Intel[®] StrongARM[®] SA-1100 Multimedia Development and SA-1101 Development Boards

Specification Update

April 1999

Order Number: 278245-001

Figure 1. Etch Cut under C35

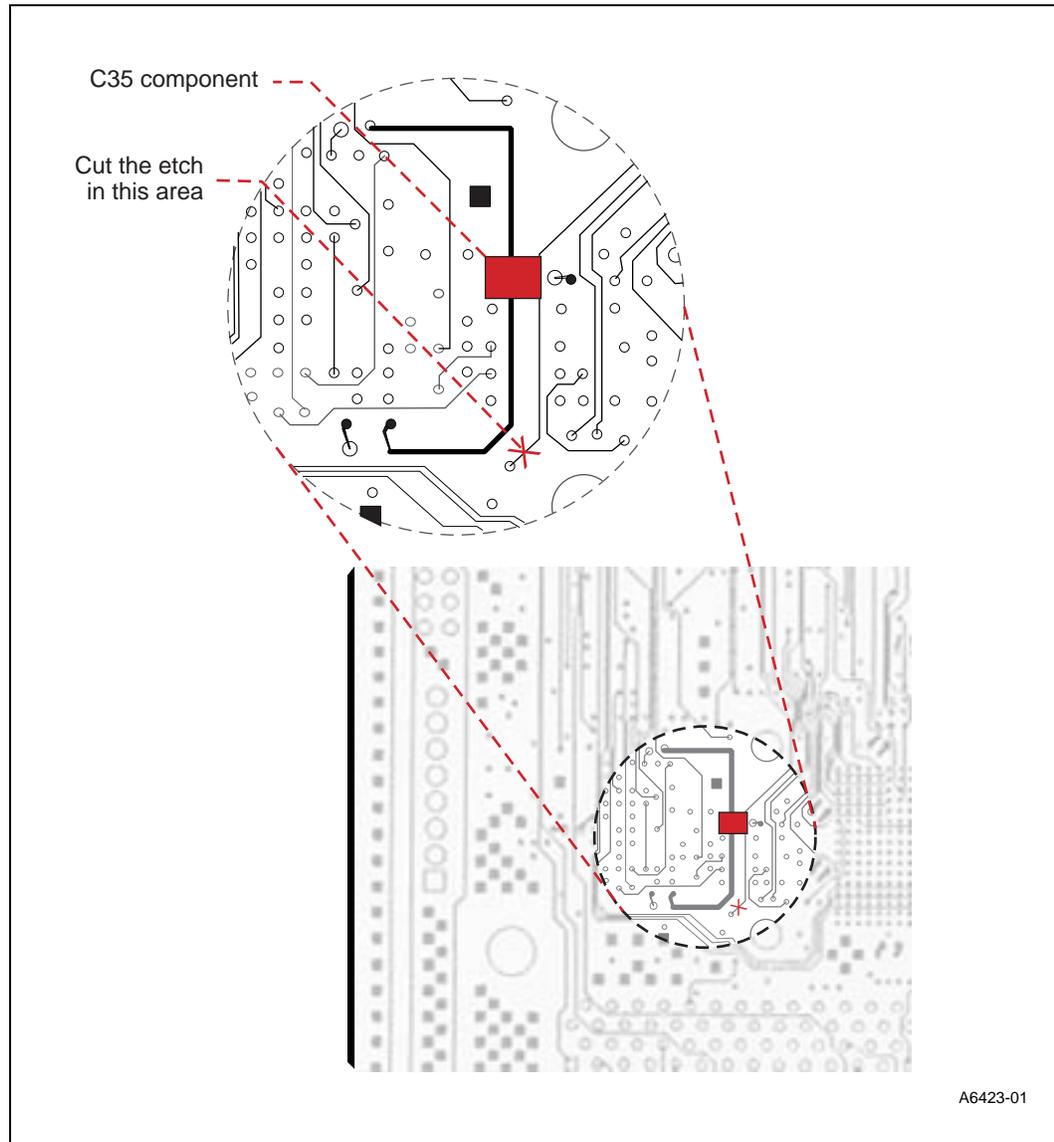
Problem: Video from VGA may be unstable due to loading on signal GPIO_CLK_27 is incorrect.

Implication: May cause an unstable SA1100 PLL signal, which may result in video jitter or intermittent USB errors.

Workaround: Cut the etch that runs under the side two component C35 (see Figure 1).

Figure 2. Keyboard Connectors

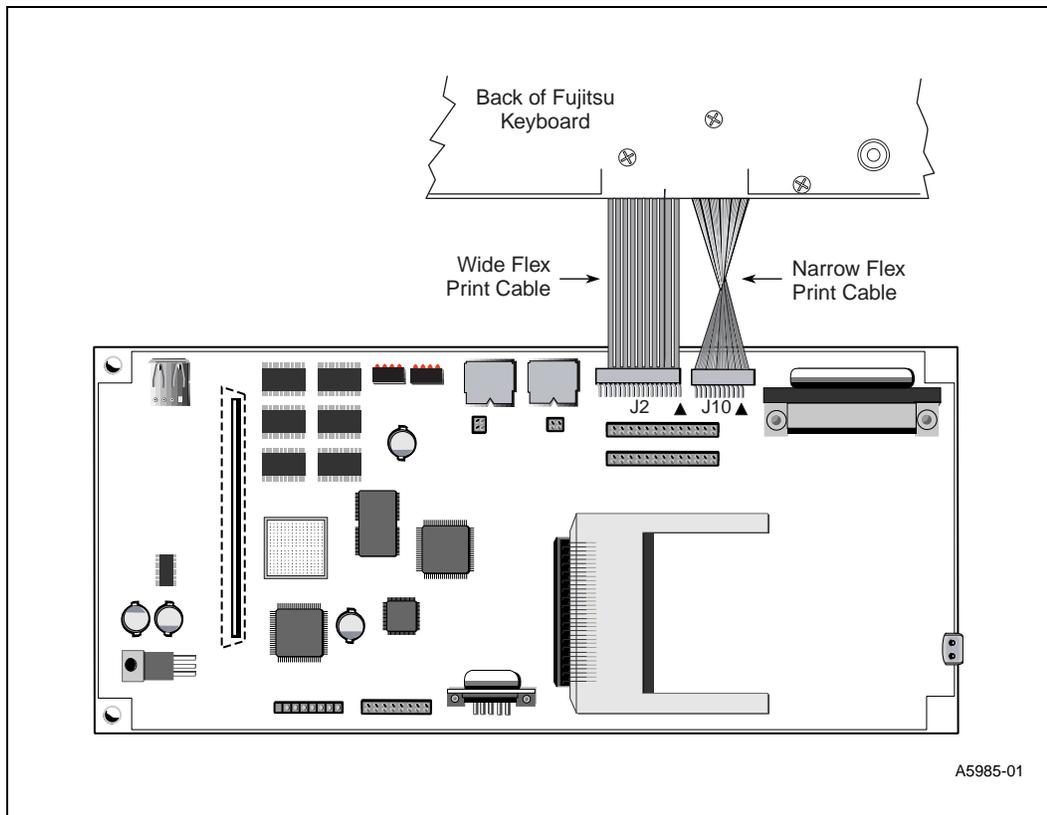
Problem: The narrow flex print cable for the Fujitsu keyboard, model number N860-1406-T001, will not make an electrical contact with J10 on the SA-1101 development board.

Implication: The Fujitsu keyboard will not function.

Workaround: Use the following procedure for connecting the Fujitsu keyboard to the SA-1101 development board (see Figure 2):

1. Locate J2 and J10 on side one of the SA-1101 development board.

2. Turn over the Fujitsu keyboard onto its keys and align pin 1 of the wide flex print cable with pin 1 of J2.
3. Insert the wide flex print cable into J2.
4. Twist the narrow flex print cable so that the black surface of the cable is facing upward, similar to the wide flex print cable.
5. Align pin 10 of the twisted narrow flex print cable with pin 10 of J2.
6. Insert the twisted narrow flex print cable into connector J10.

Figure 3-1. SA-1100 Multimedia Development Board

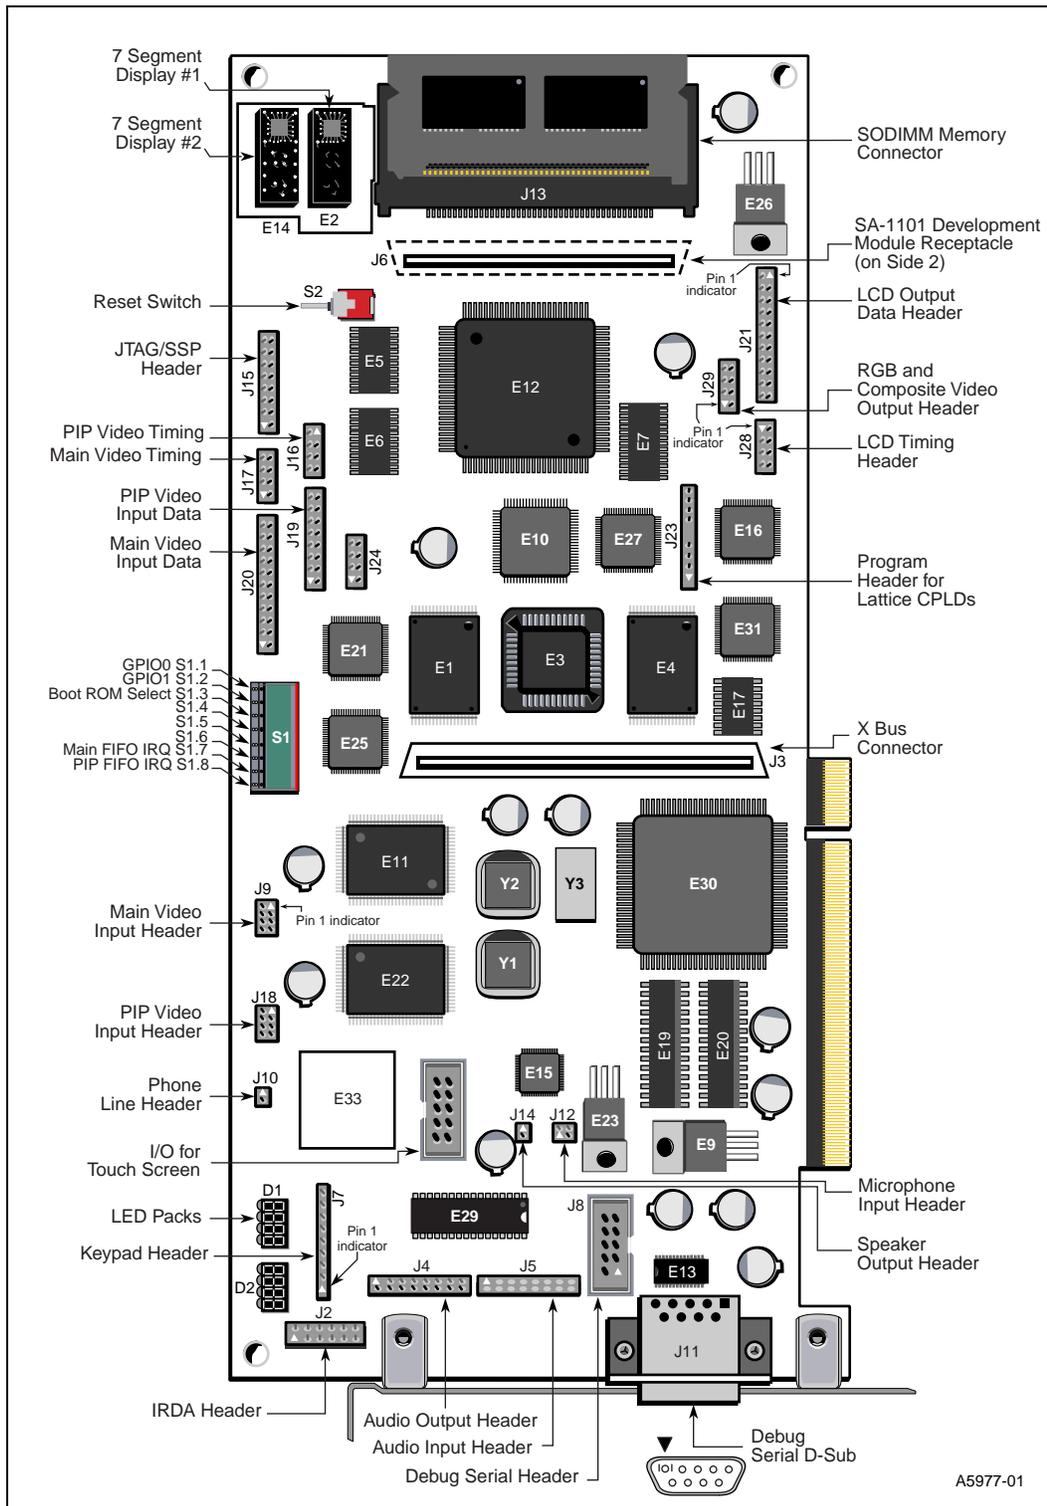
2. SA-1100 Multimedia Development Board: Figure 3-1

- Changed the name of J11, “Debug Serial Header #2” to “Debug Serial D-Sub.”
- Changed the name of J8, “Debug Serial Header #1” to “Debug Serial Header.”
- Added “Boot ROM Select,” “Main FIFO IRQ,” and “PIP FIFO IRQ” to S1.

Figure A-2. S1, S2, LEDs, Keypad, Debug, X Bus, Daughter Card and SODIMM Connector

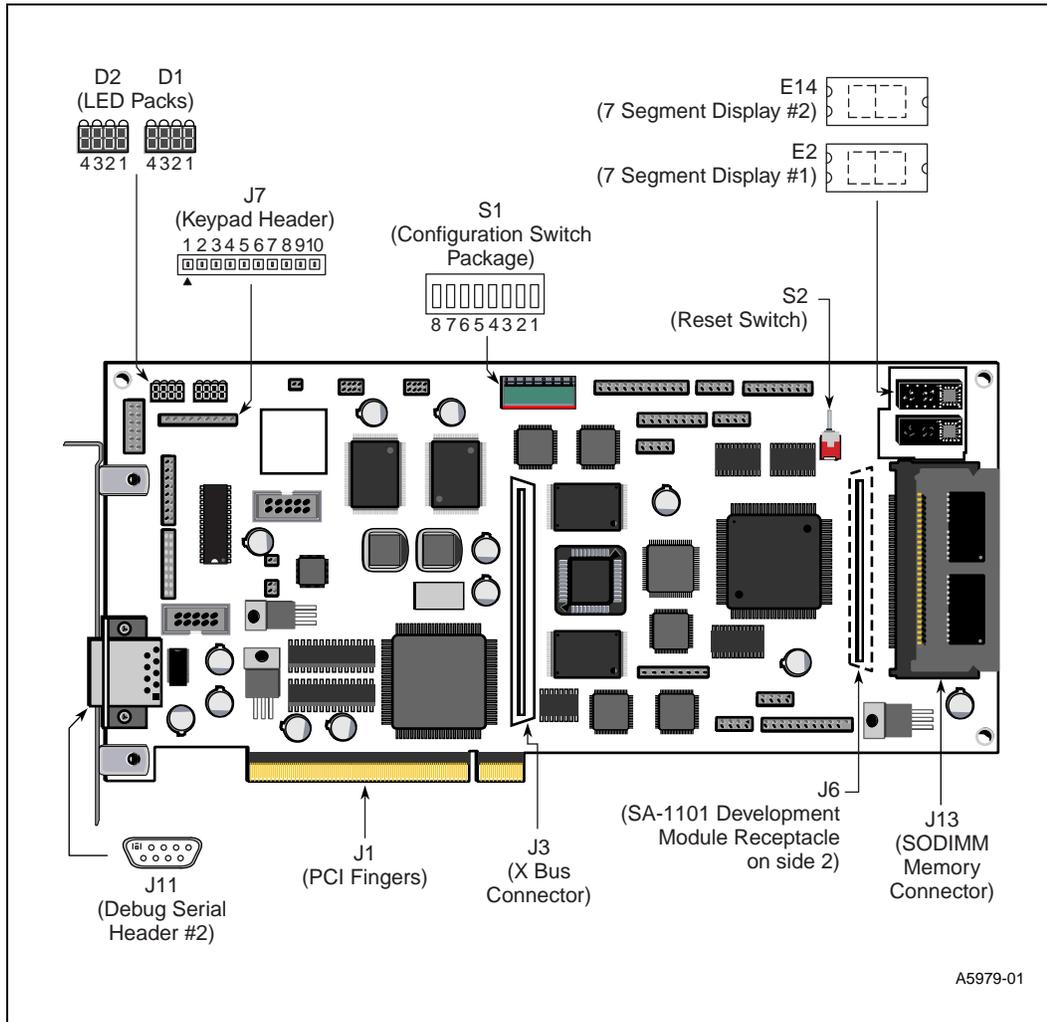
13. S1, S2, LEDs, Keypad, Debug, X Bus, Daughter Card and SODIMM Connector: Figure A-2

Added J6, SA-1101 Development Board Receptacle and J3, X Bus Connector.

Figure A-6. IrDA, JTAG, LCD, and Debug Ports and Headers

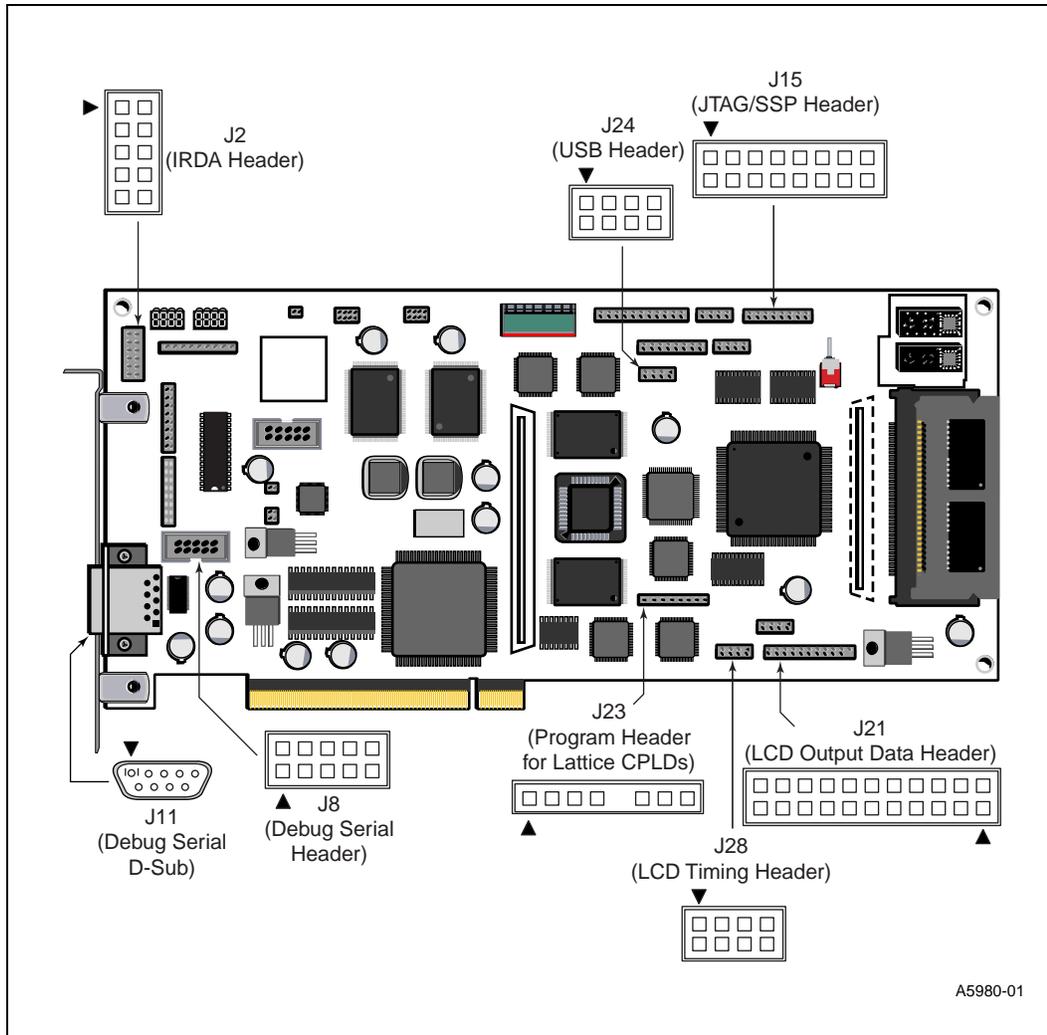
17. IrDA, JTAG, LCD, and Debug Ports and Headers: Figure A-6

- Changed the name of J8, “Debug Serial Header #1” to “Debug Serial Header.”
- Changed the name of J11, “Debug Serial Header #2” to "Debug Serial D-Sub."

Figure 3-2. SA-1101 Development Board

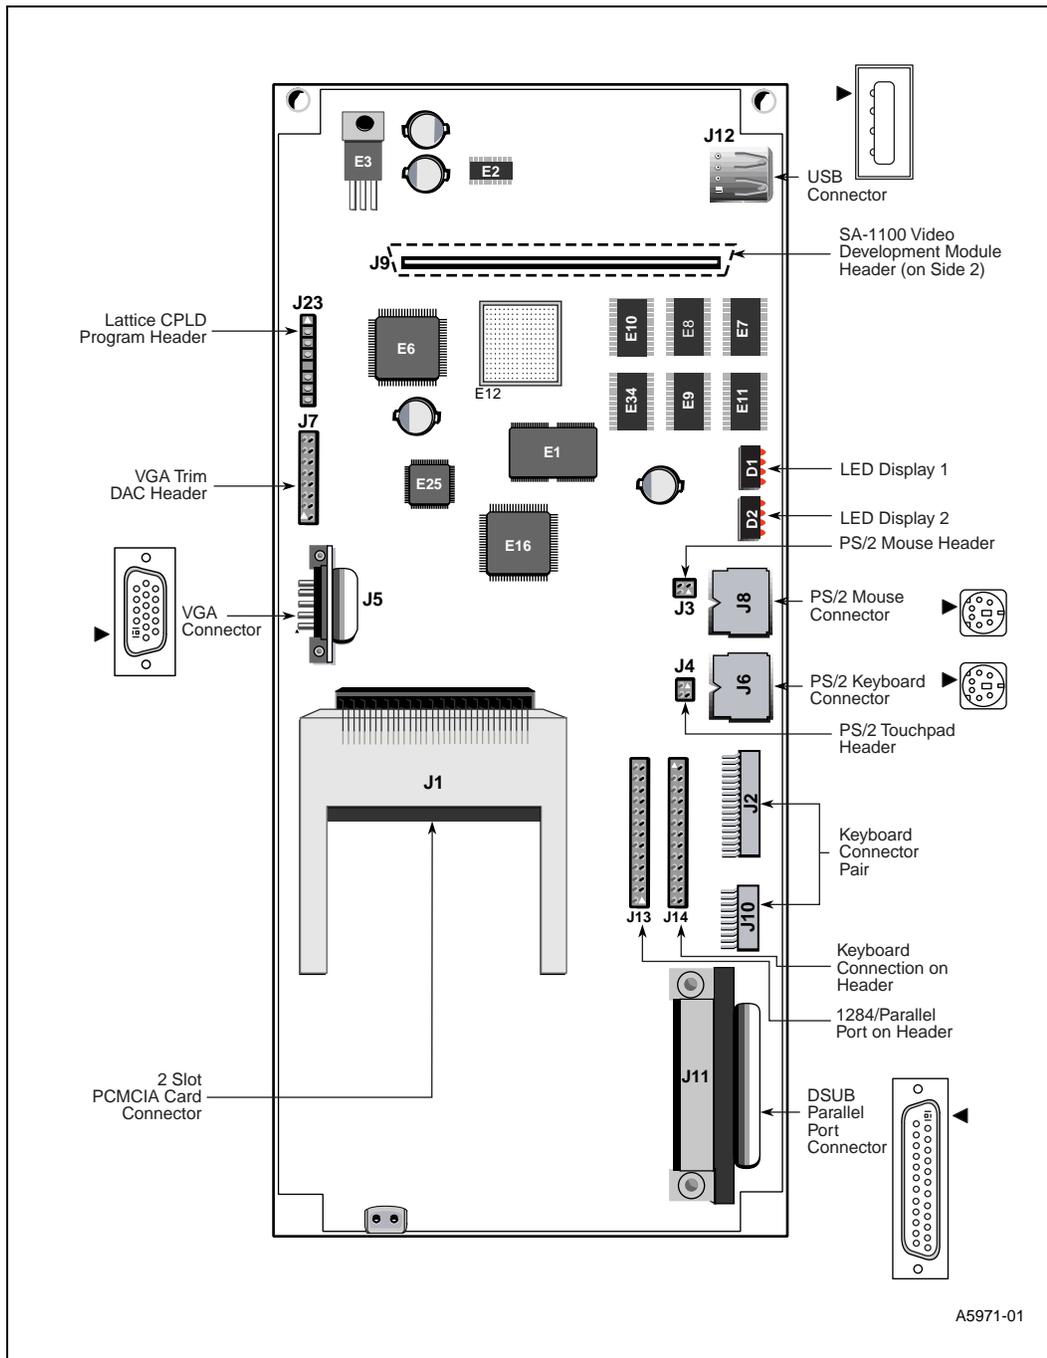
1. **Optional SA-1101 Development Board: Figure 3-2, Figure B-1**
 - Changed the name of J5, “RGB Cable Connector” to “VGA Cable Connector.”
 - Changed the name of J7, “RGB Trim DAC Header” to VGA Trim DAC Header.”

Figure 3-5. Keyboard Connectors

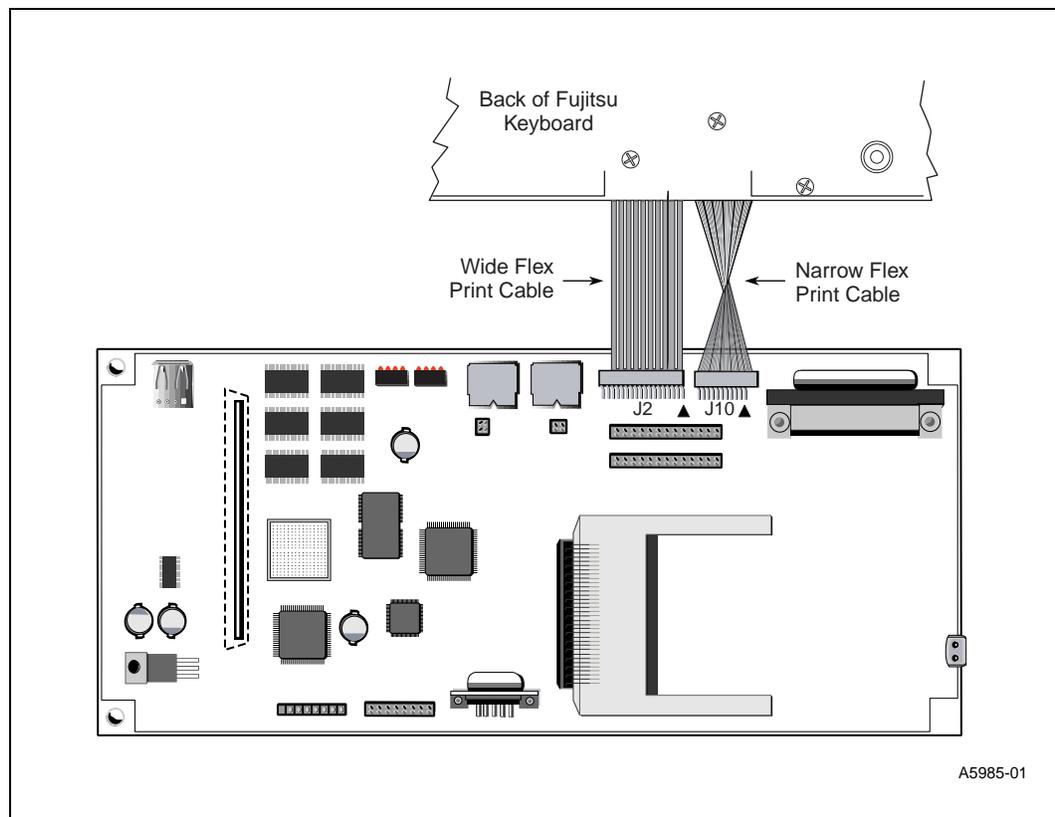
2. Cables for Optional SA-1101 Development Board: Section 3.5

Changed the procedure for connecting the narrow flex print cable, changed the number of pins from 9 pins to 15 pins, changed the name of “RGB connector” to “VGA connector,” and “RGB Cable Connector” to “VGA Cable Connector,” and ribbon cable to flex print cable.

Note: The flex print cables for the keyboard are center justified with connectors J2 and J10, resulting in unused pins on the left side of J2 and on the right side of J10. Please see Figure 3-5 for proper insertion of the keyboards two flex print cables.

Figure B-3. Keyboard Connectors

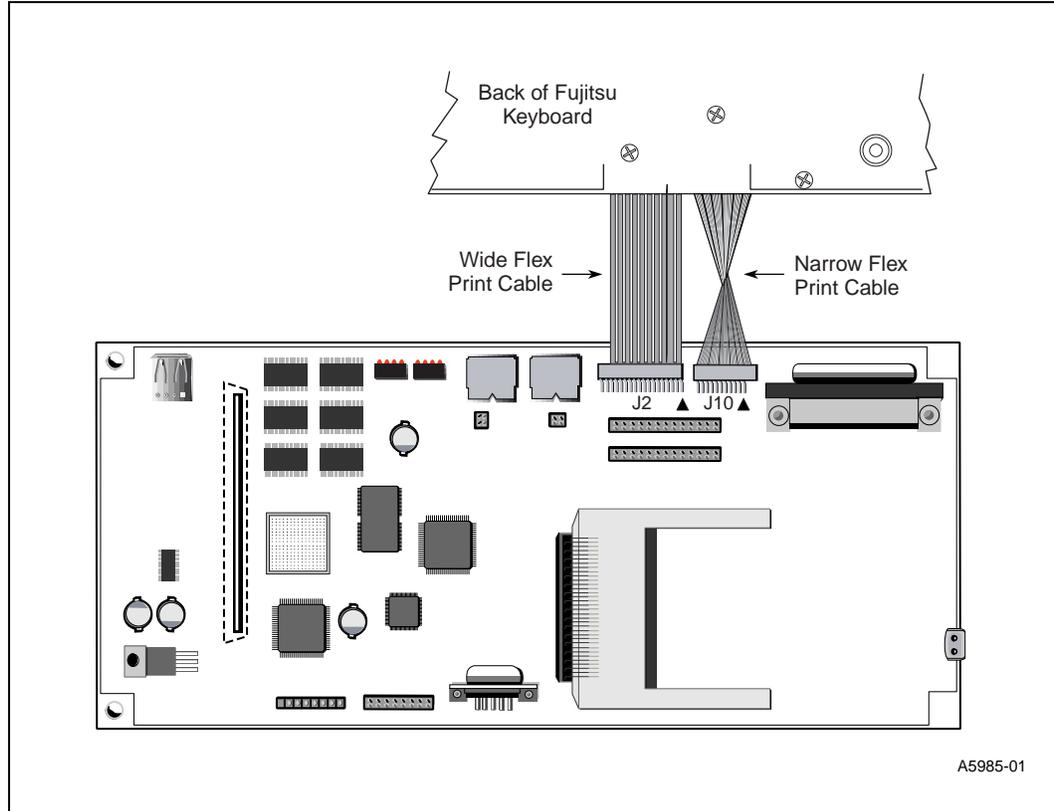
5. Keyboard Connectors: Figure B-2

The figure now appears as follows, indicating a twist in the narrow flex print cable:
